MEMORANDUM

RE: Fairfax Parkade, Fairfax – Field Change Directive (FCD 001)

**TREE REMOVAL EXHIBIT
PER TOWN OF FAIRFAX AND URBAN
FORESTRY ASSOCIATES, INC
UPDATE OF 2013 TREE
INSPECTION.**

**FAIRFAX PARKADE IMPROVEMENT PROJECT
SIGNING, STRIPING, AND ELECTRICAL PLAN**

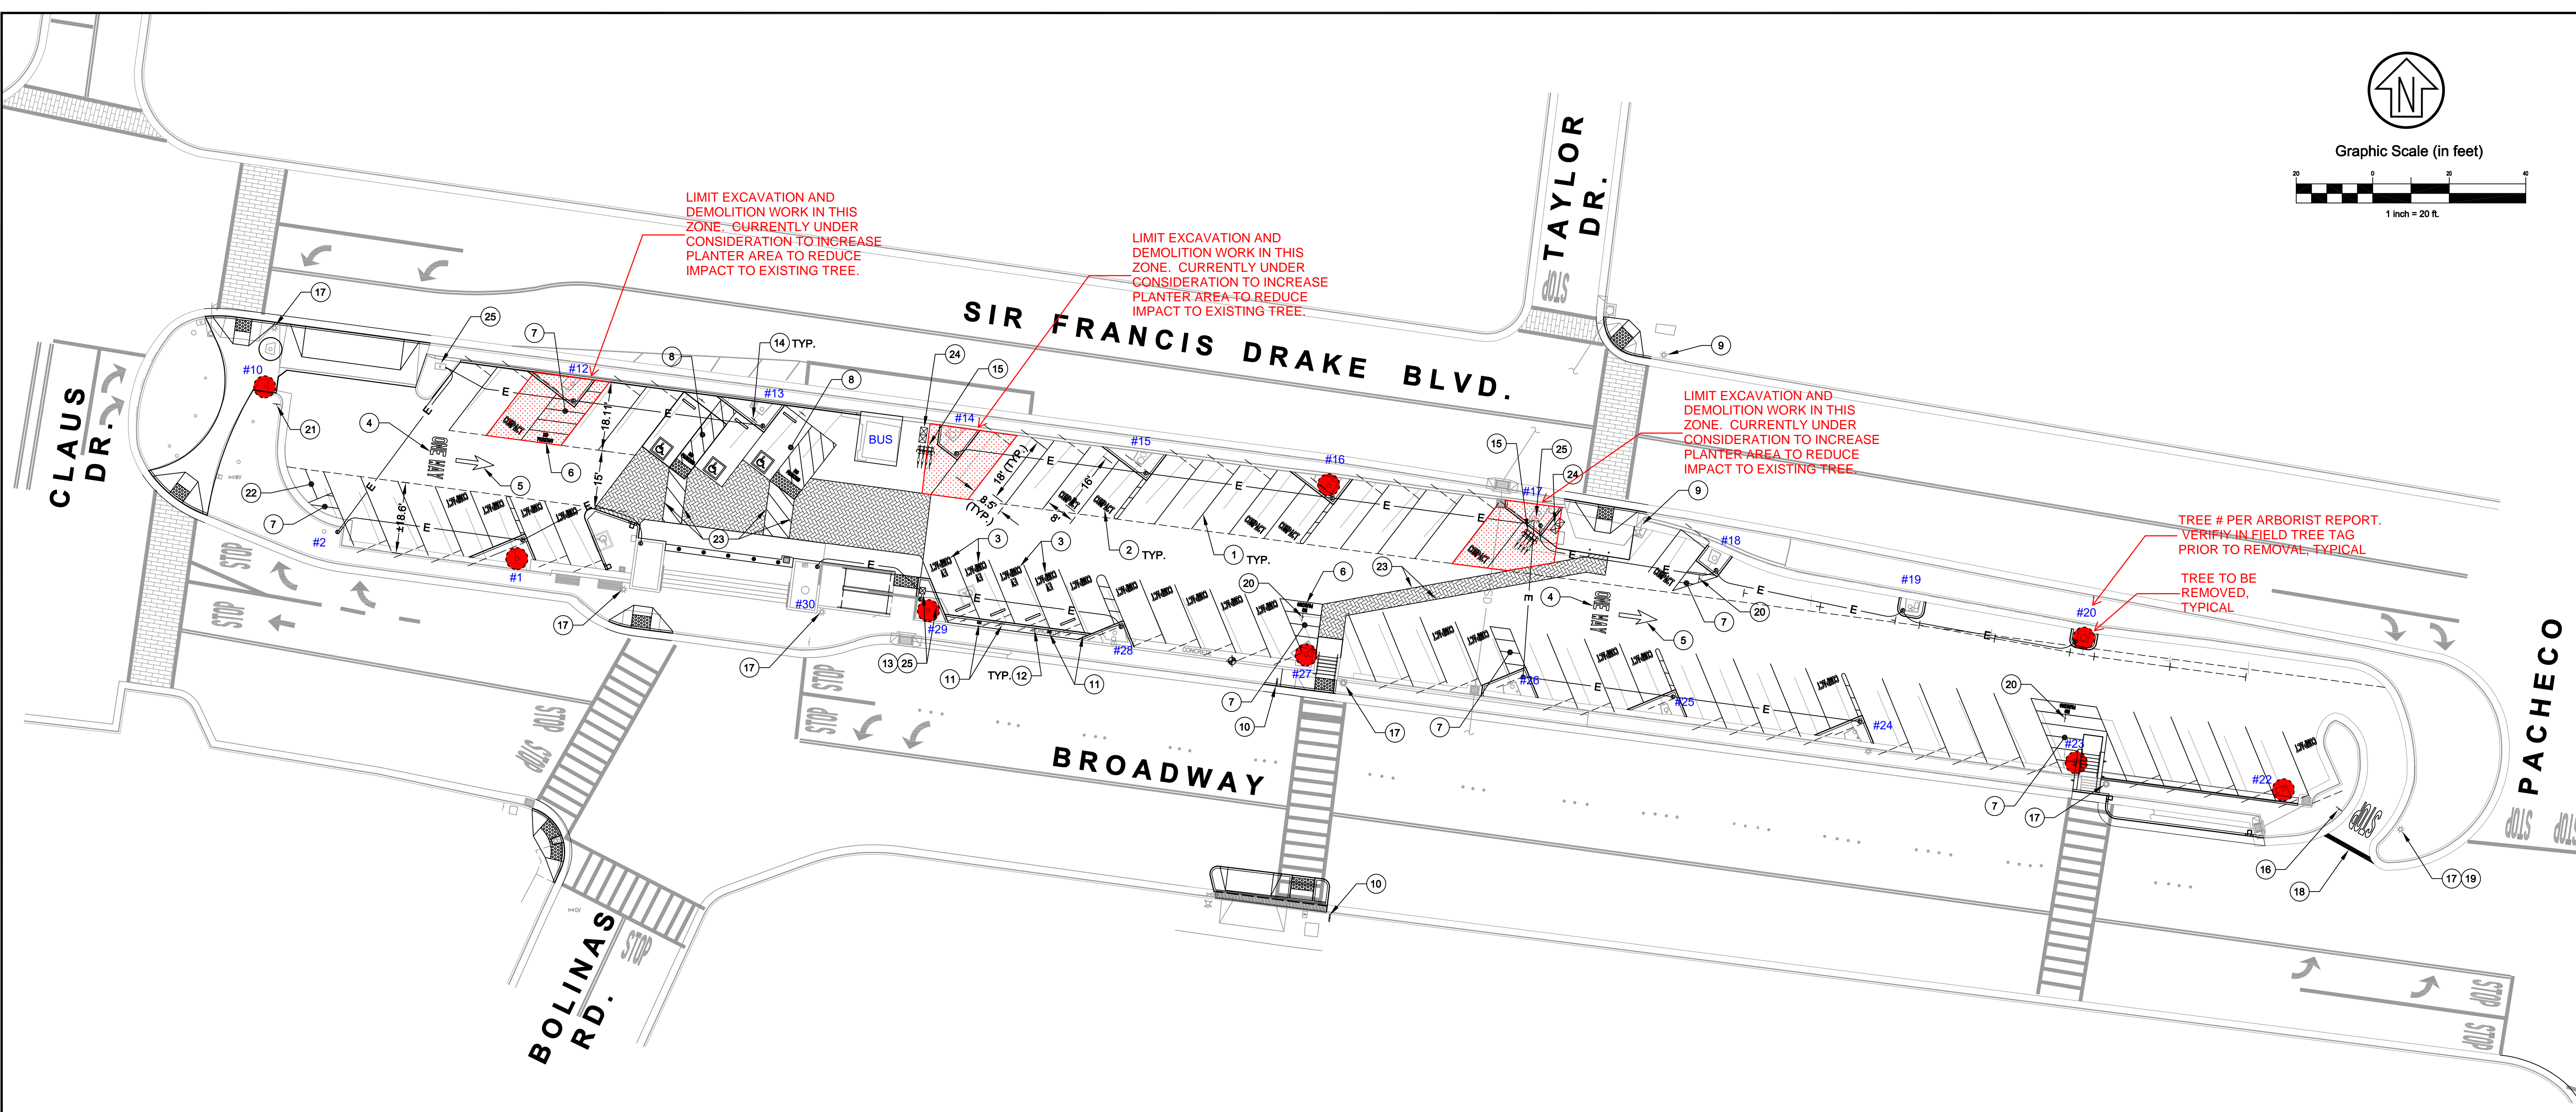
1. In addition to the 4 trees identified (#10, #22, #23, #27) in the bid documents to be removed the contractor shall include in the removal trees identified and tagged as #1, #16, #20, and #29.
2. In addition, the demolition and excavation area around trees #12, #14, and #17 shall be reduced in order to increase the chance of survival. The proposed curbed tree well is under consideration to be increased. Further direction with respect to any reconfigured tree well will follow.
